**Supporting contribution to comments #429~436
regarding error ratio allocation in optical PMD clauses**

Huawei Technologies Co., Ltd

Introduction

Figure 176B-2—xBASE-R PHYs with one and two physically instantiated interfaces

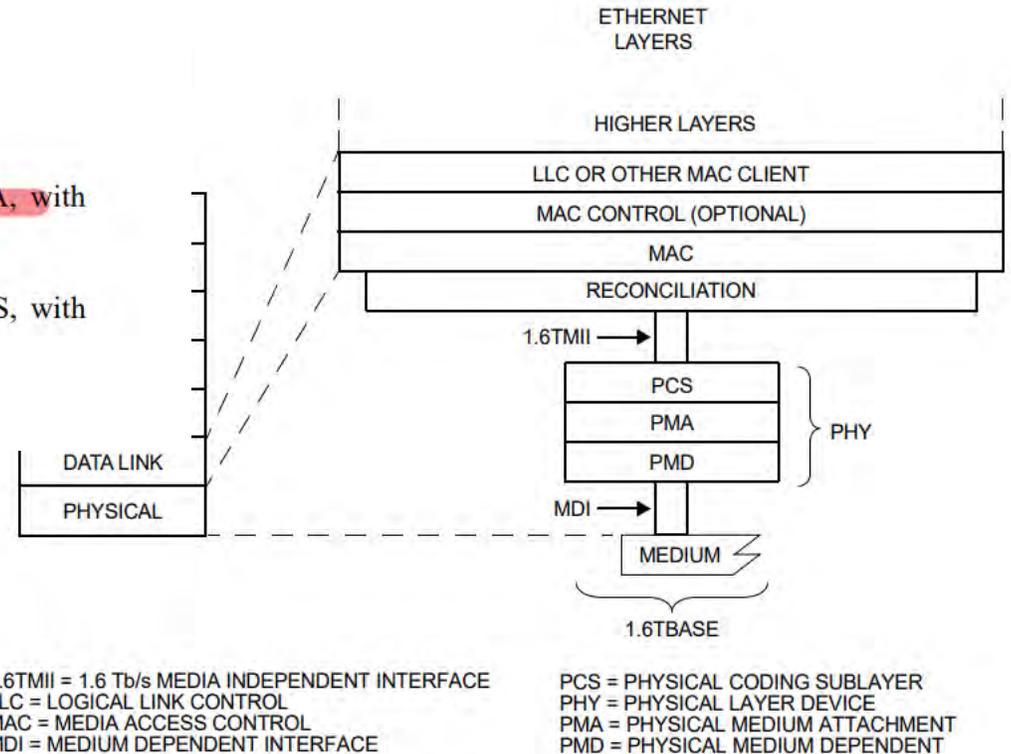
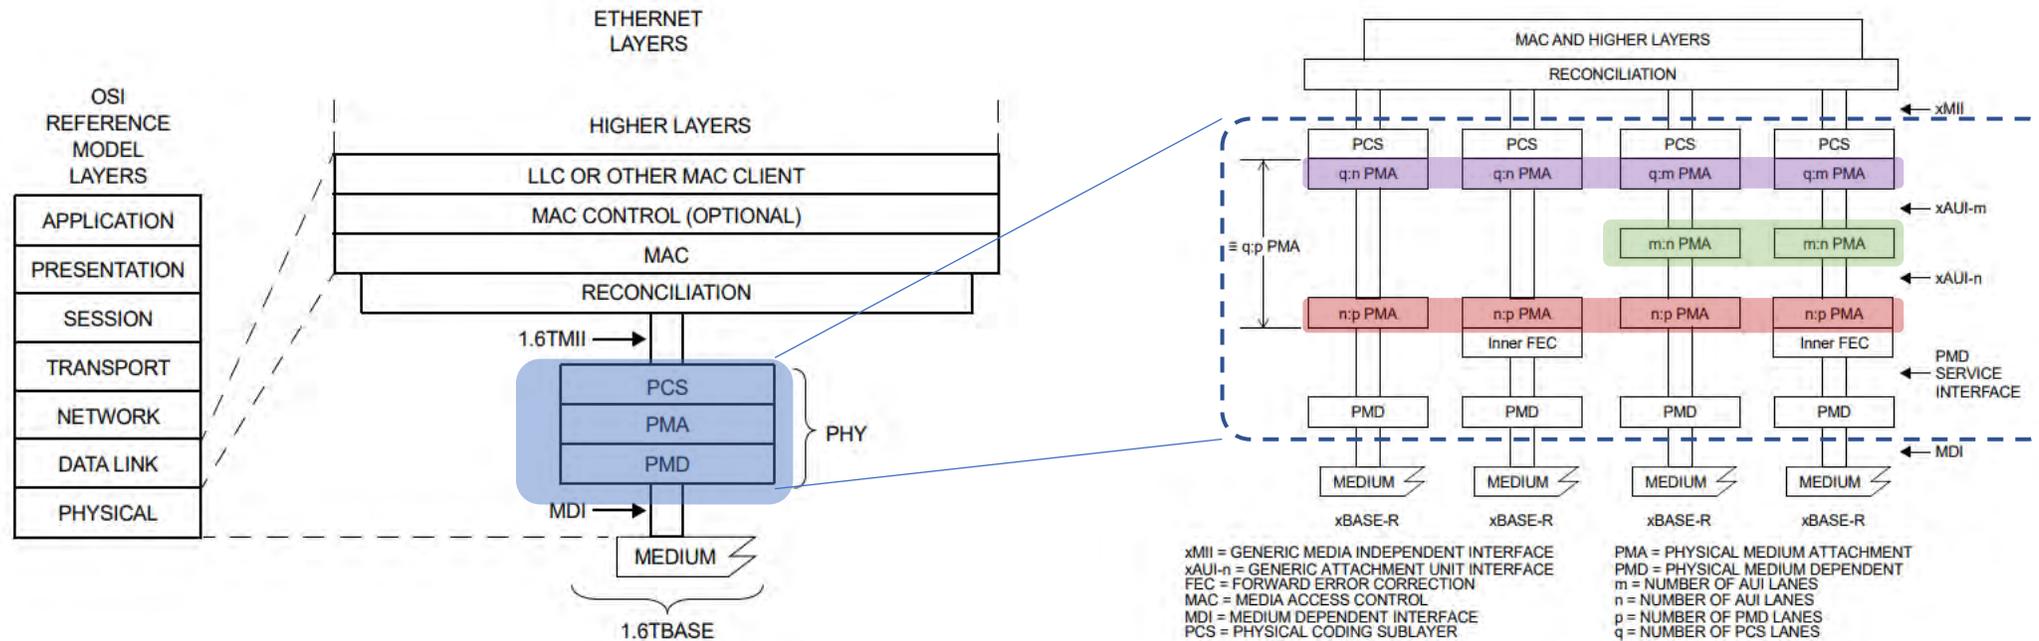
1. Immediately before(transmit direction) and after(receive direction) PMD service interface (no AUI included) ← Error ratio
2. In between xAUI-n and xAUI-m (including only the AUI C2Ms)
3. Immediately after PCS (including all AUI interfaces that the data stream will pass)

A PMD is expected to meet the block error ratio specifications in 174A.6, **measured at a PMA**, with $\text{BER}_{\text{added}}$ equal to 6.4×10^{-5} .

Measured between the two PMAs immediately adjacent to the PMD in both the transmit and receive direction.

Referencing to Figure 176B-2 will be helpful too.

Figure 176B-2—xBASE-R PHYs with one and two physically instantiated interfaces

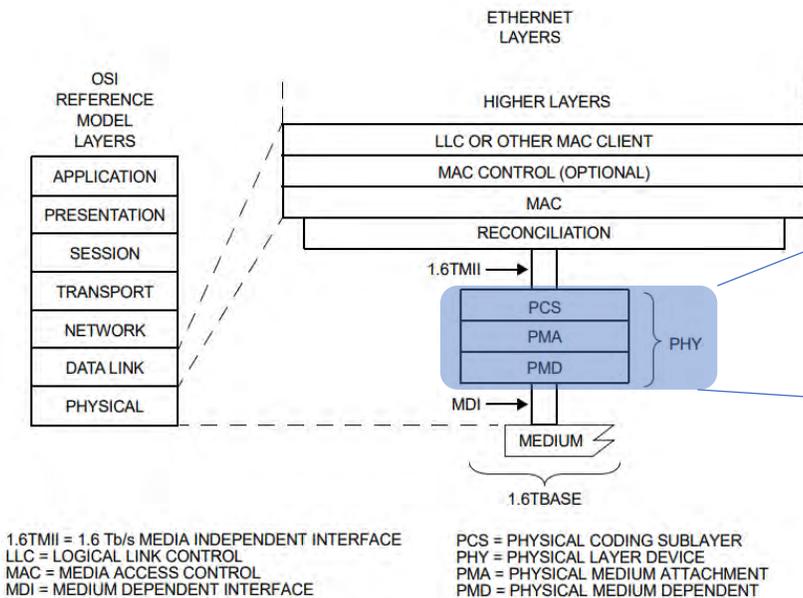
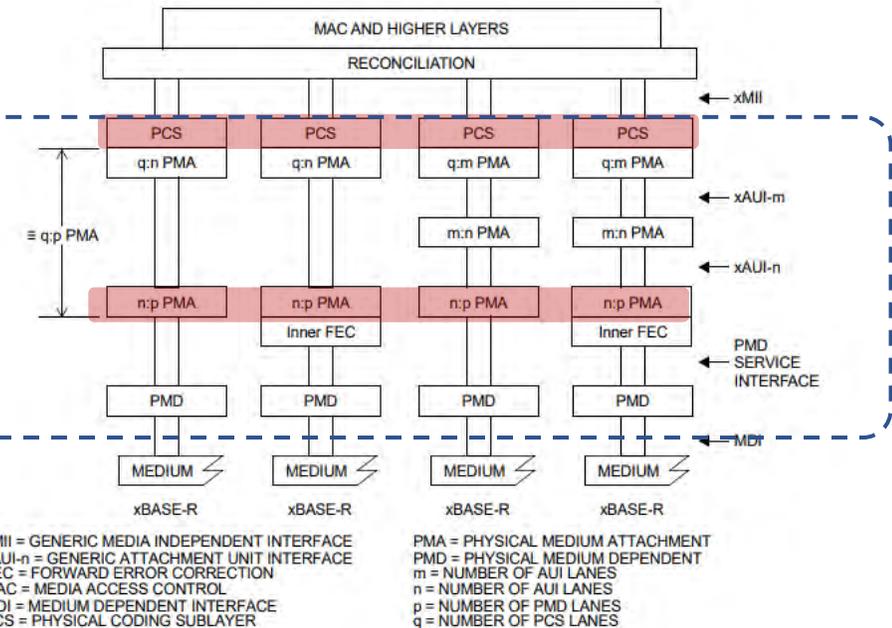
Error Ratio considered at PCS is measured with contribution of AUIs, with two possible variations on where transmit starts:

Scrambled Idle transmitted from	AUI instantiation passed when Received at PCS
PMA immediately above the PMD service interface	Max. 2 AUI instantiation, depending on test fixtures.
PCS	Max. 4 AUI instantiation. Depending on test fixtures.

- **Inconsistency, subject to hardware:** Switch testbed/BERT that will be used for module validation could have different implementation of electrical channel/AUI.
- **Optimistic:** Count in the error ratio contribution of AUI implemented in the test fixture, though the physical implementation of AUI interface(s) may not observe the worst case contribution to error ratio, i.e., BER_{added}
- **Pessimistic:** It is also possible to disregard the error ratio contribution of any AUI that may have been incorporated in the measurement setup, but does put a more stringent requirement on the PMD.

Author's view: pessimistic option may be the easier choice to unify all variations of test fixture and equipment.
